**DURHAM CATHOLIC
DISTRICT SCHOOL BOARD**
Learning and Living in Faith

**T24-02 Kindergarten Outdoor Playground Renovations - Three (3) Schools
& St. Patrick Catholic School - Field and Site Improvements
Addendum No # 3**

L2

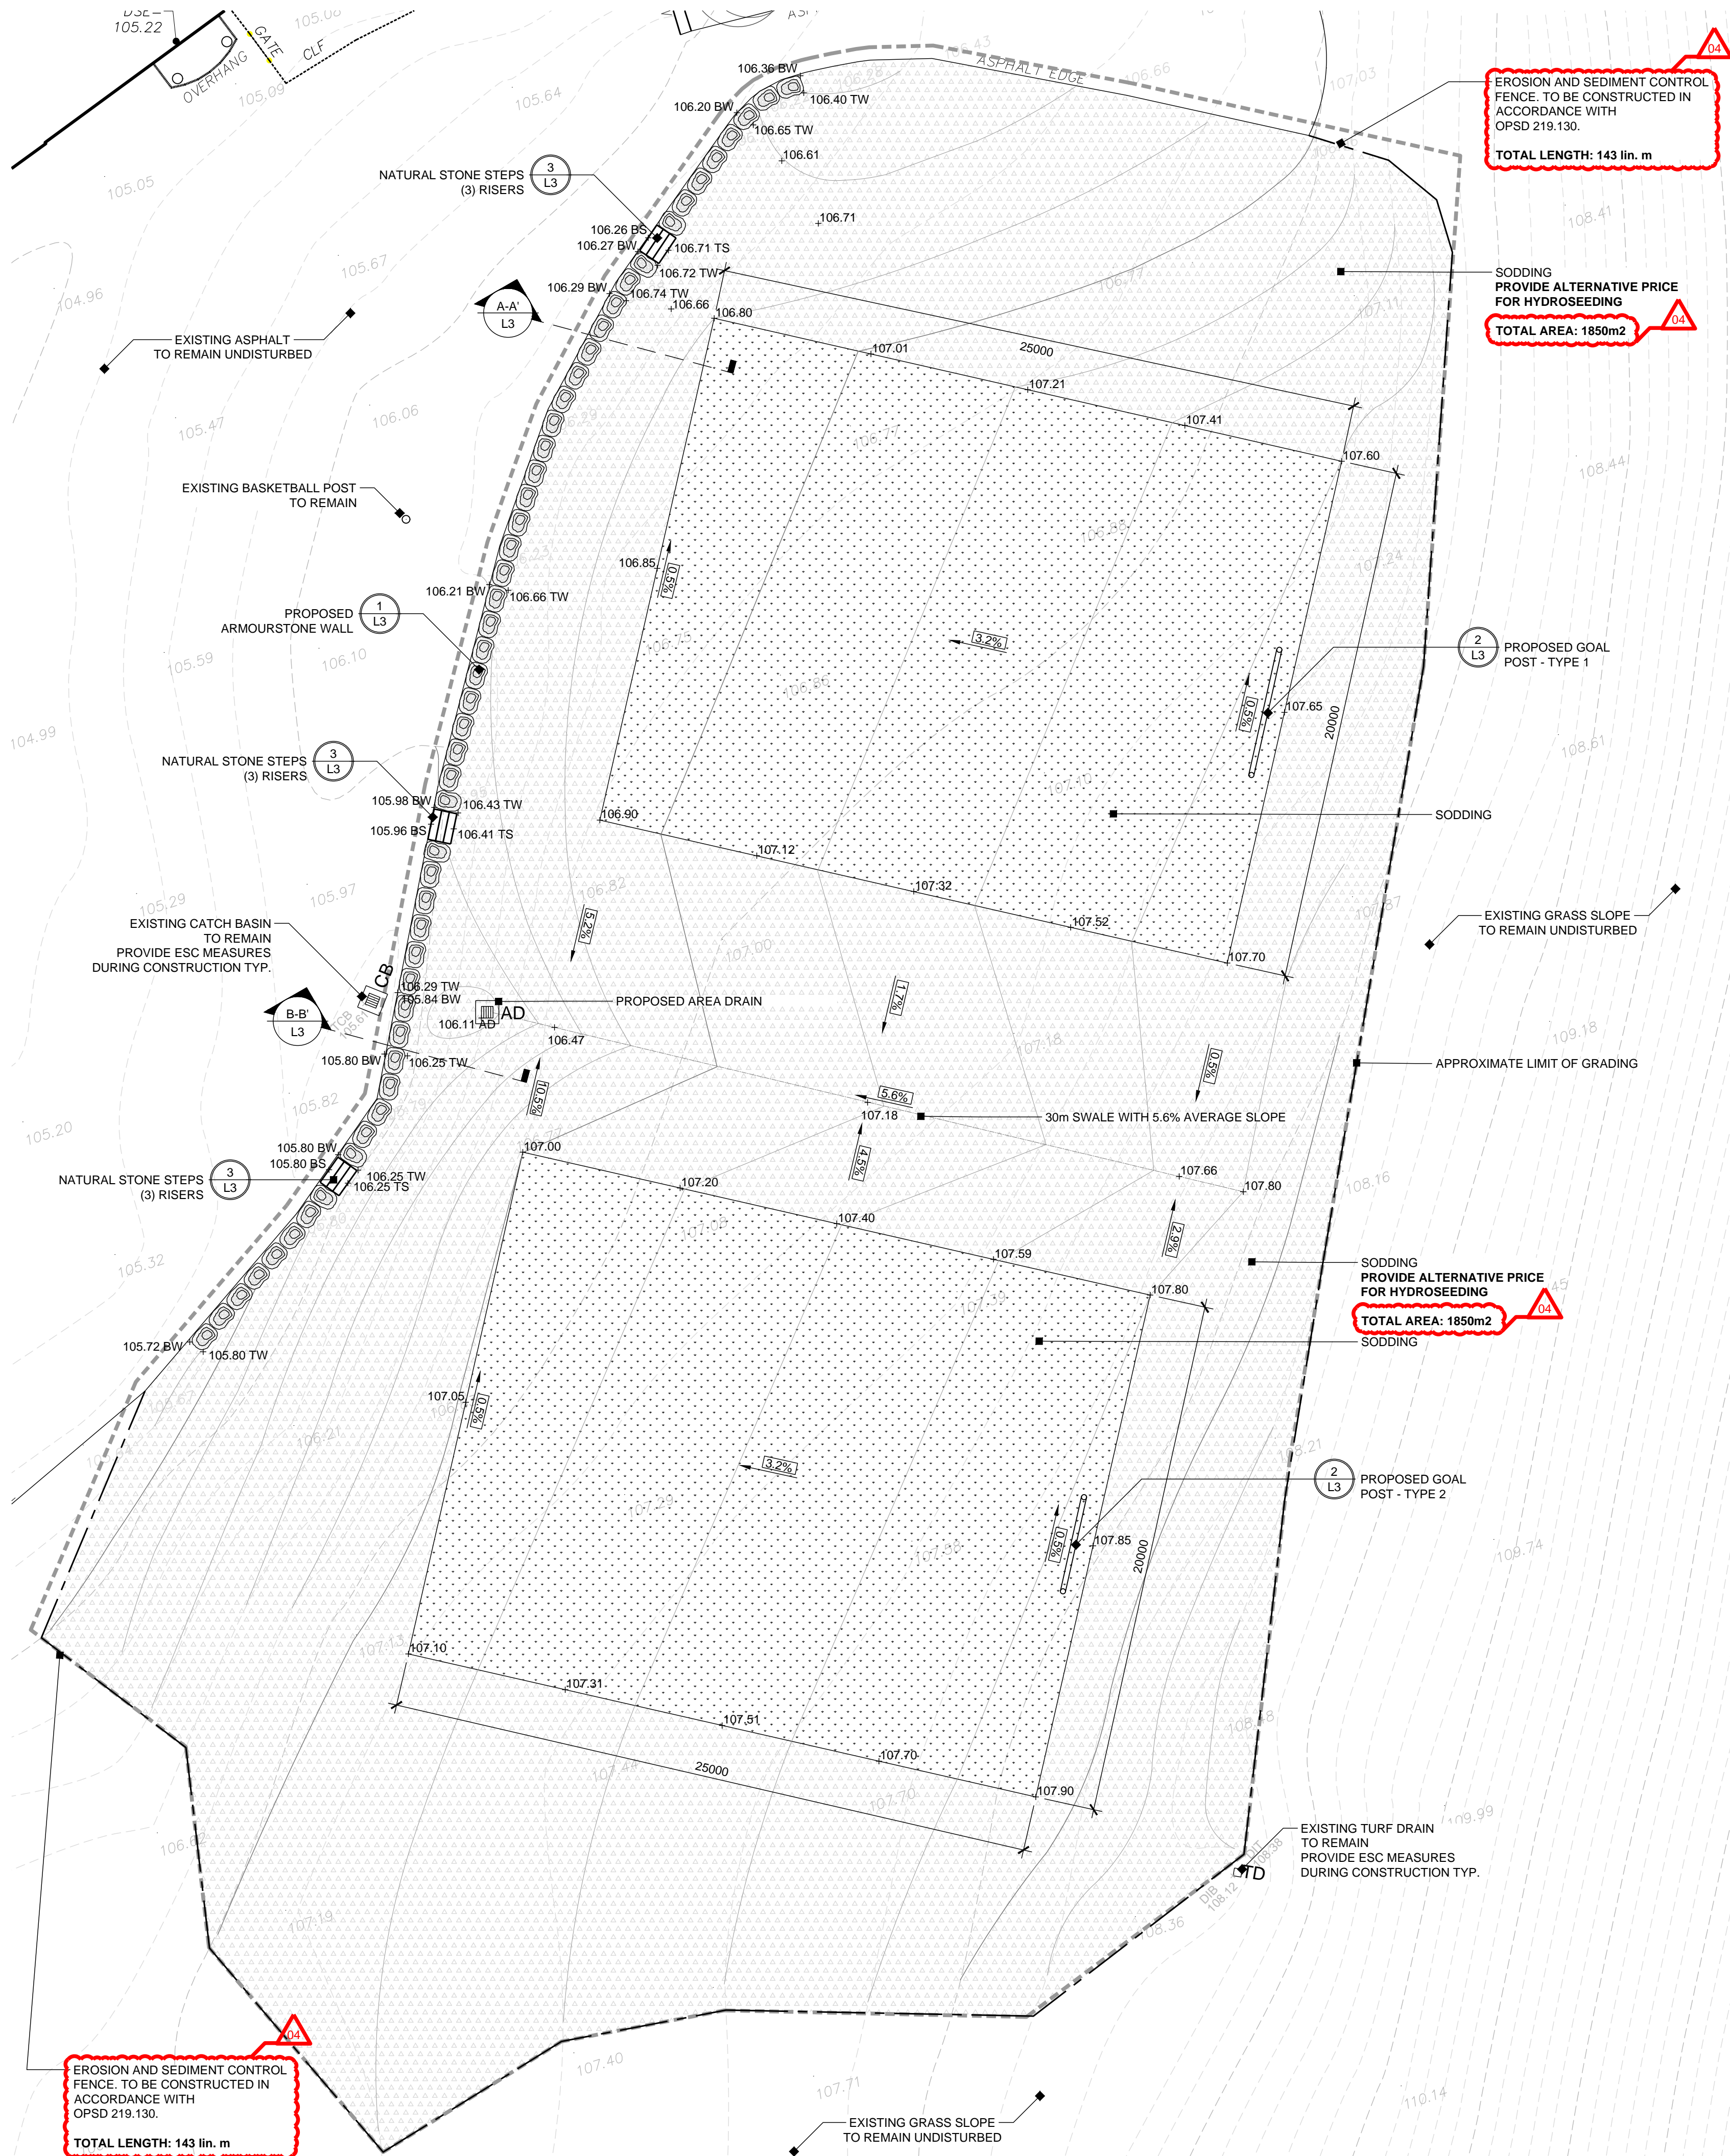
Question 2: @ St. Patrick School, regarding the extent of erosion and sediment control measures at this site, will this be limited to protection of the catch basins only, or are additional measures such as a silt fence also required to prevent potential run-off onto paved areas?

Question 3: @ St. Patrick School, the site plan only shows a single goal on each pitch (18' x 6' and 16' x 6'); is this correct, or should there be two goals for each?

Question 8: For St. Patrick, the drawings mention providing an alternate price for seed in lieu of sod but there is nowhere to provide an alternate price. Please advise.

Answer 2: Please find updated drawing for St. Patrick attached 'Addendum No. 3 - 23-020_St. Patrick_SHEET L2'. Erosion and Sediment Control fence added. Catch basin silt capture measures to remain.

Answer 3: Two (2) goal posts are required. Refer to drawing L2.

Answer 8: Appendix C1 – Electronic Pricing Form – Alternate Prices is updated to include a line item for an alternative price for hydroseed in lieu of sod. Please find attached to 'Addendum No. 3 - 23-020_St. Patrick_SHEET L2' for St. Patrick, providing area calculation for alternative hydroseed.
